**BASELINE MONITORING
DOCUMENT AND AS-BUILT
BASELINE REPORT
FINAL**

SANDY BRANCH MITIGATION SITE

RE: As-Built Baseline Report Sandy Branch Mitigation Site, DMS ID# 100060
Cape Fear River Basin – CU# 03030003
Chatham County, North Carolina
Contract No. 7527

We have reviewed the comments on the As-Built Baseline Report for the above referenced project dated April 5, 2021 and have revised the report based on these comments. The revised documents are submitted with this letter. Below are responses to each of your comments. For your convenience, the comments are reprinted with our response in italics.

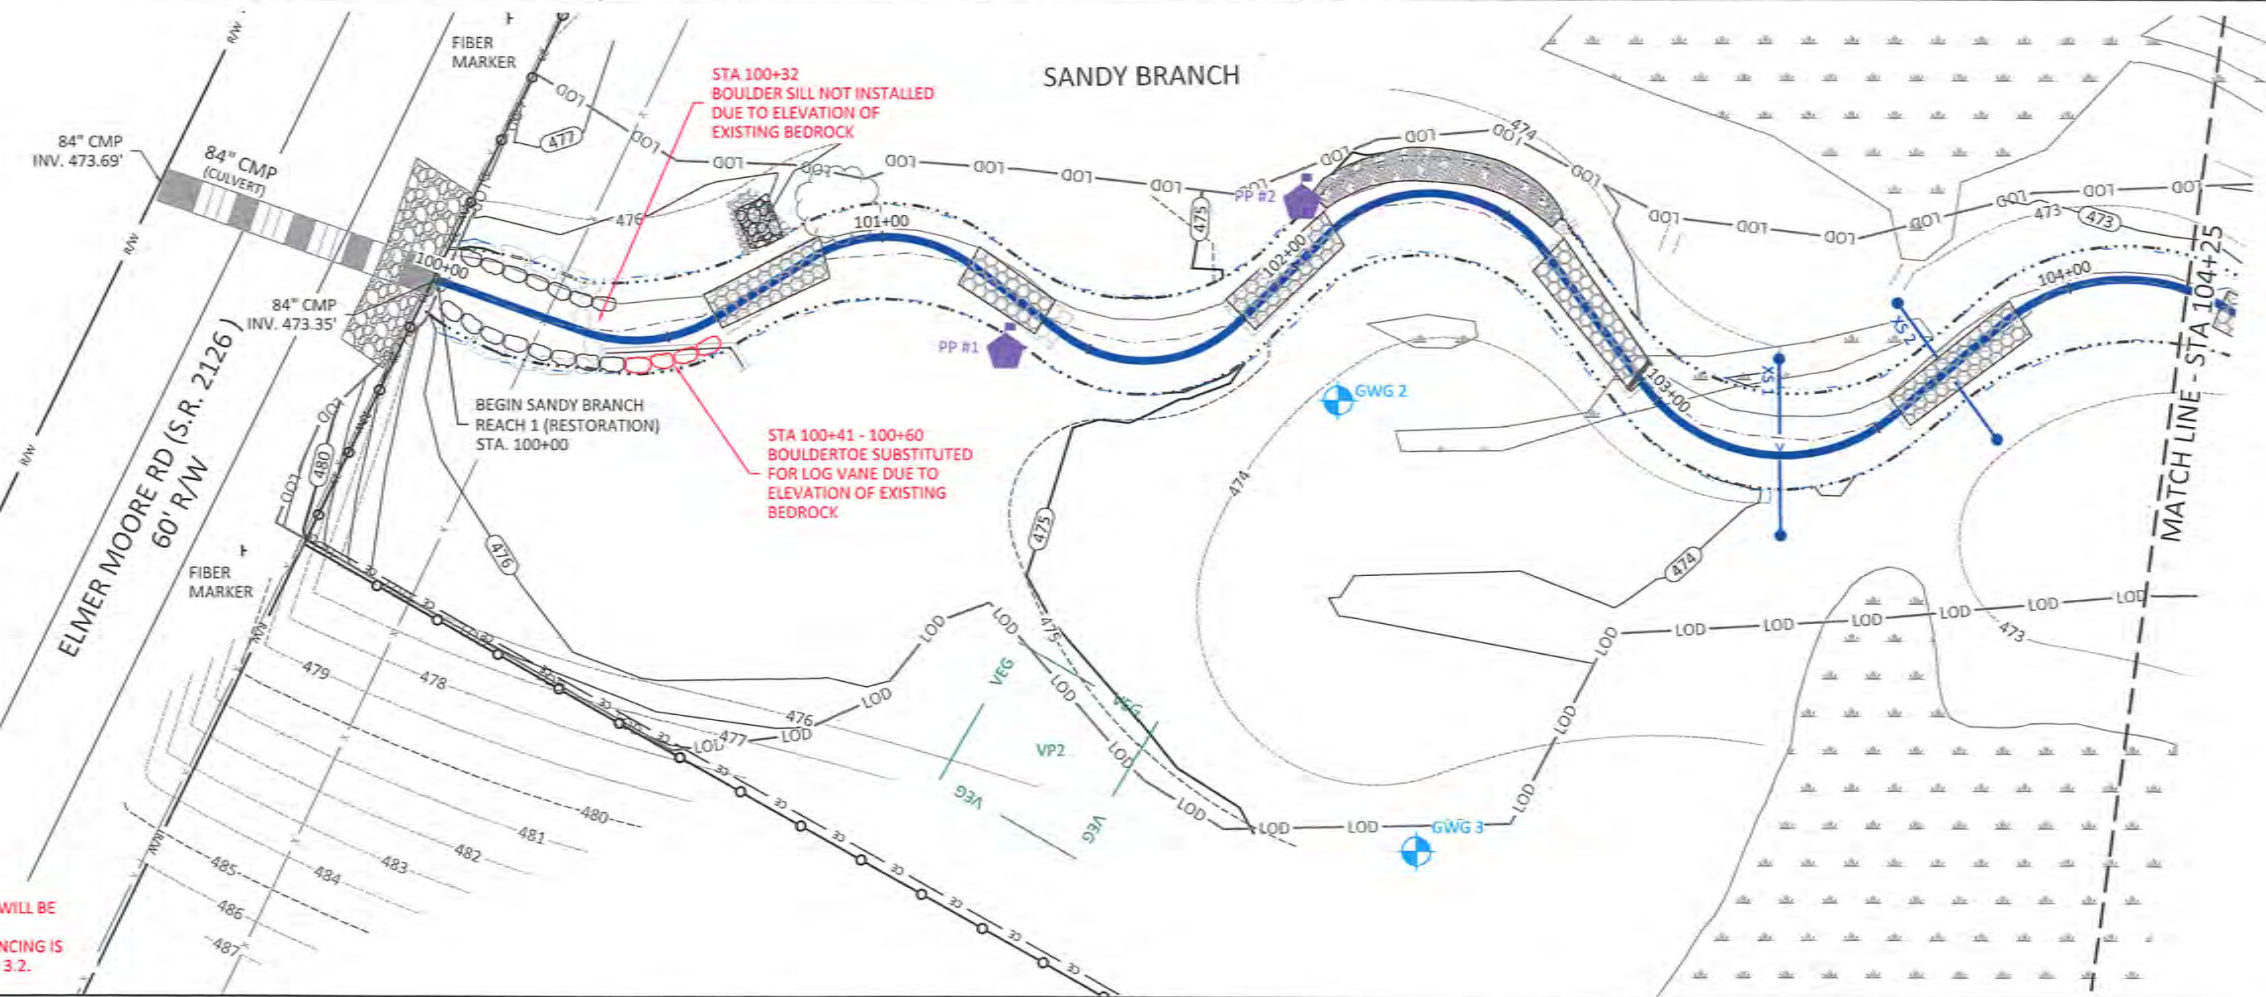
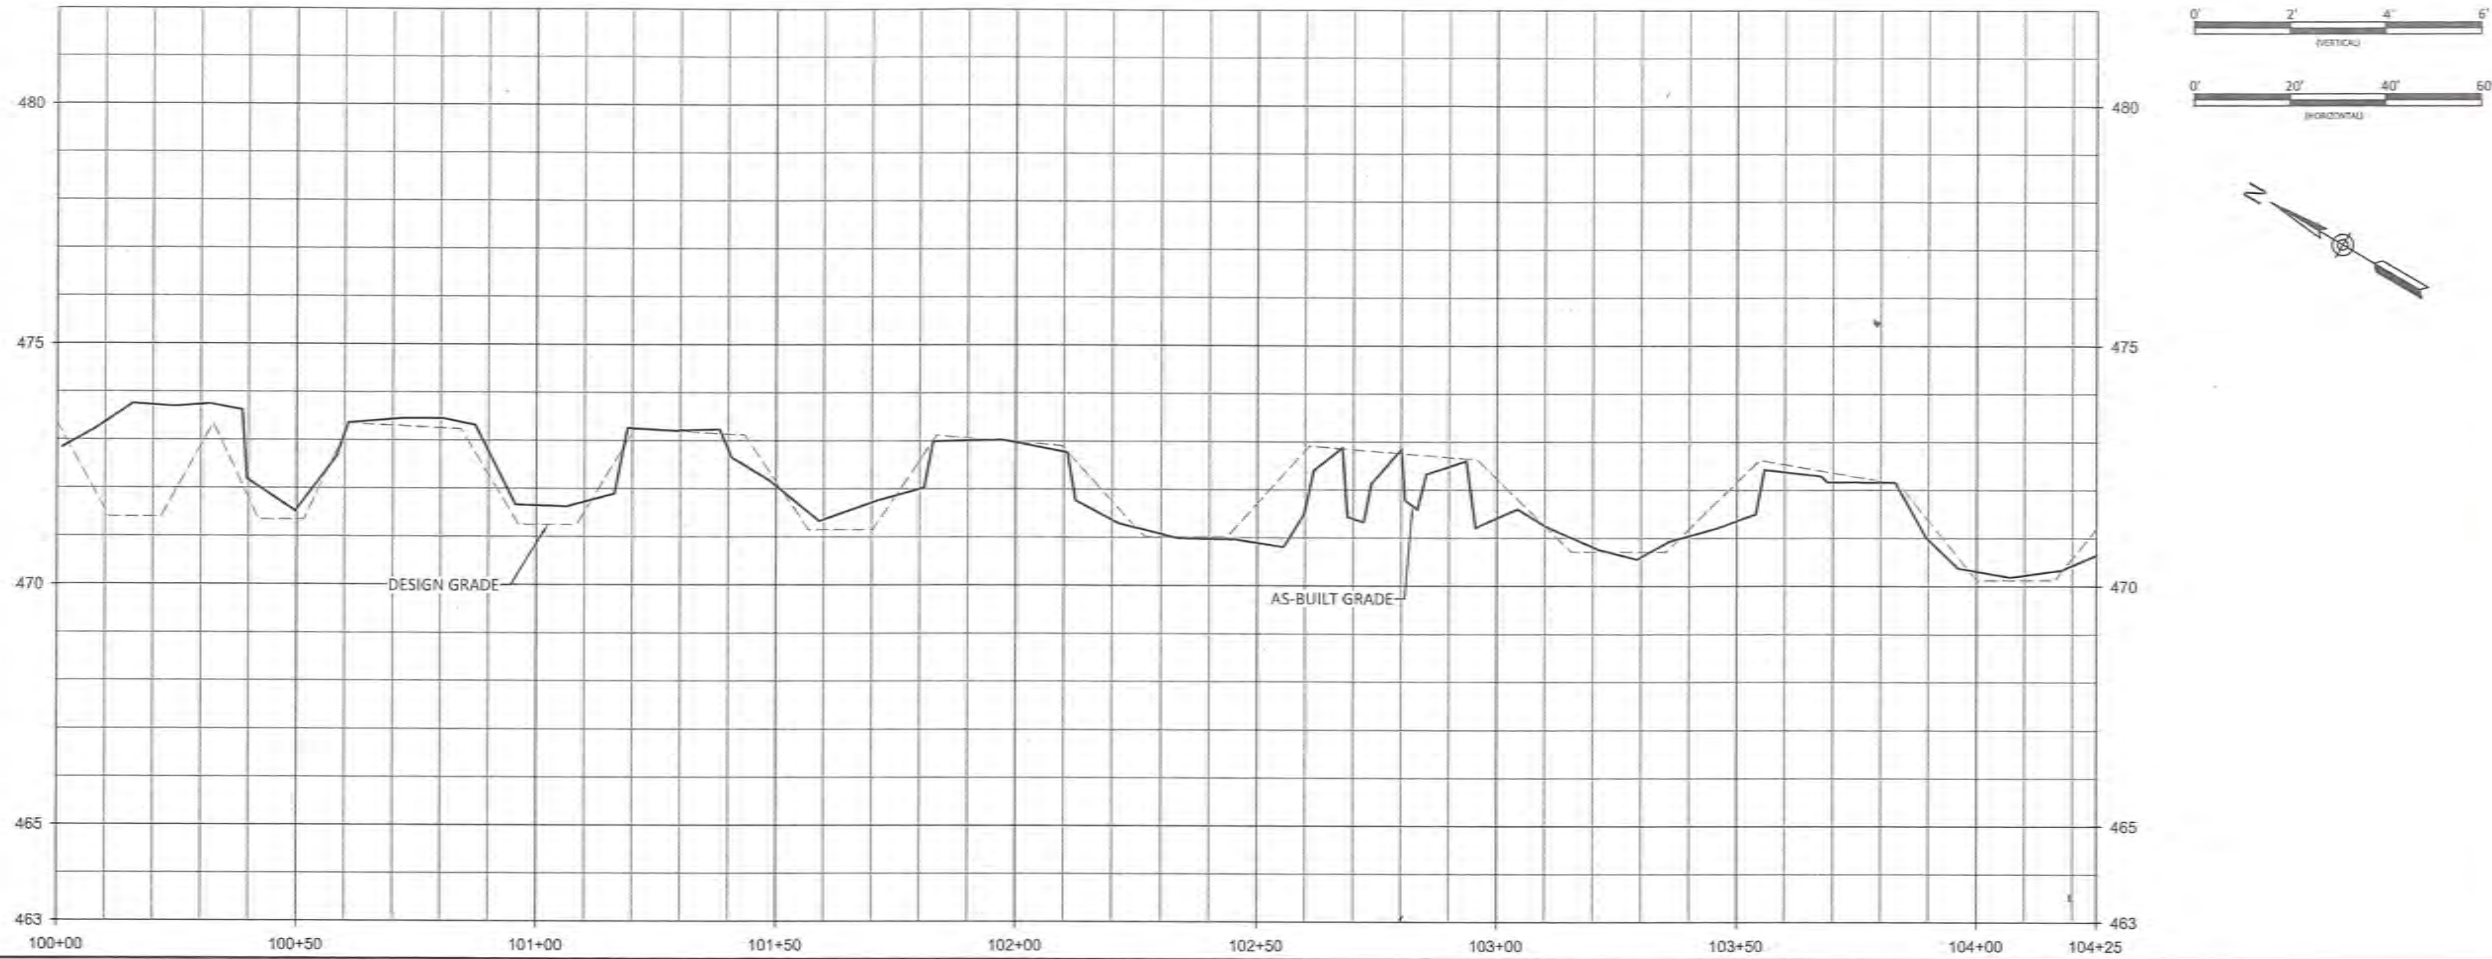
- b. Sheet 0.3: Under the As-Built features, the As-Built 5' Major Contour has 1' intervals in the plan sheets. Recommend removing 5' or 1' contour line from drawings, or fixing the 5' contour lines.

Contour lines were updated in the drawings.

1.08

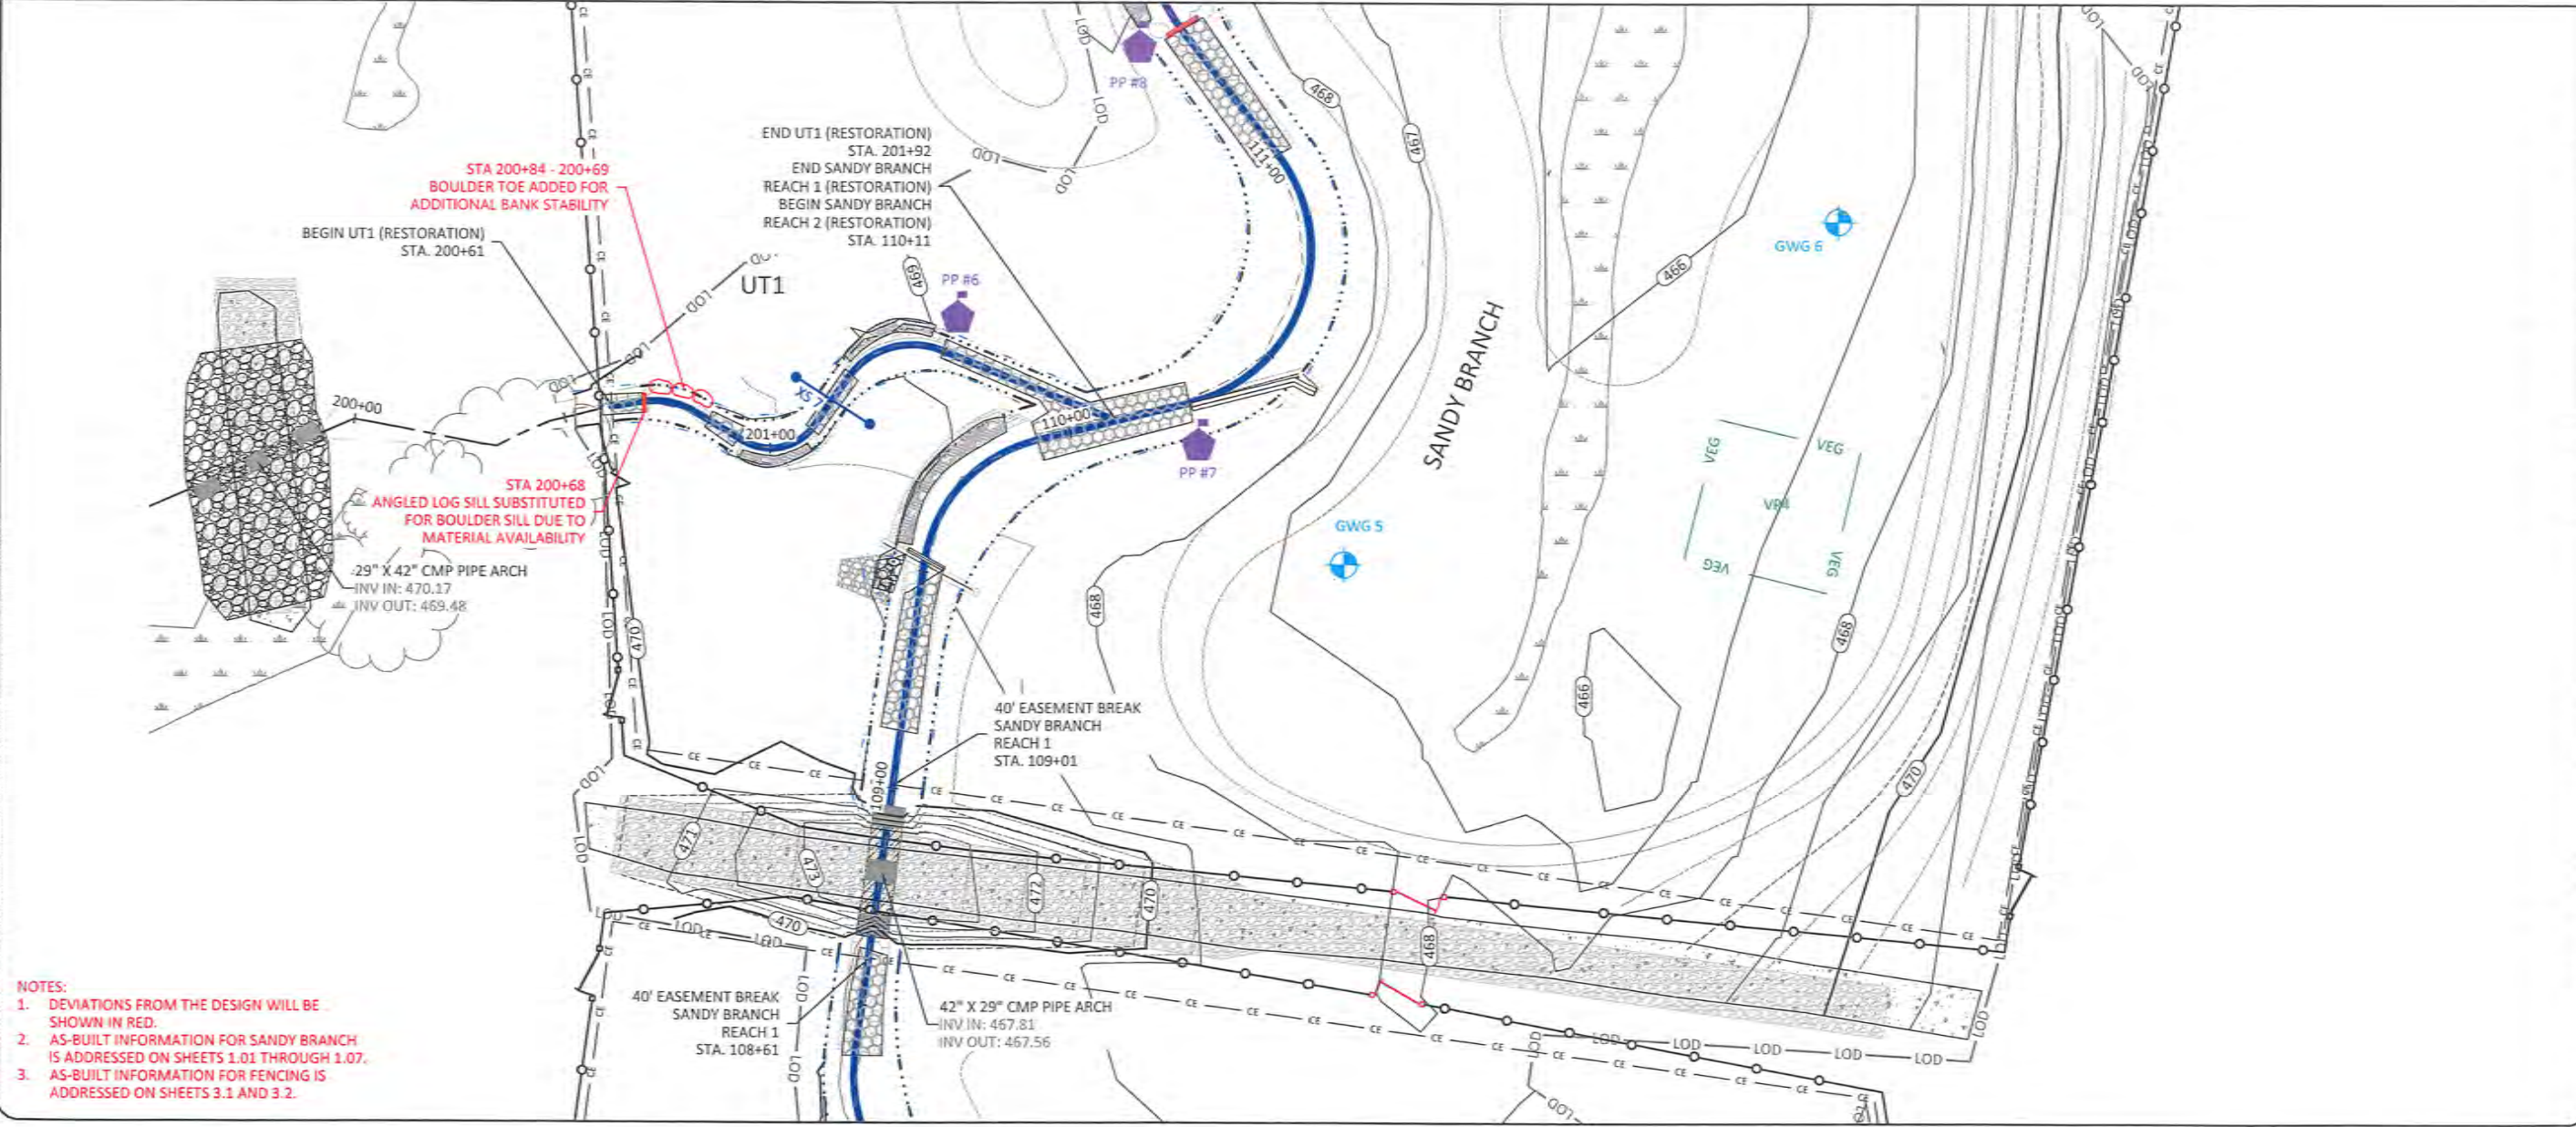
- c. Sheet 1.08: Please consistently label features. For example, MW5 & MW6 on Sheet 1.08 should be GWG5 and GWG6.

Feature names were changed to be consistent throughout all plan sheets.
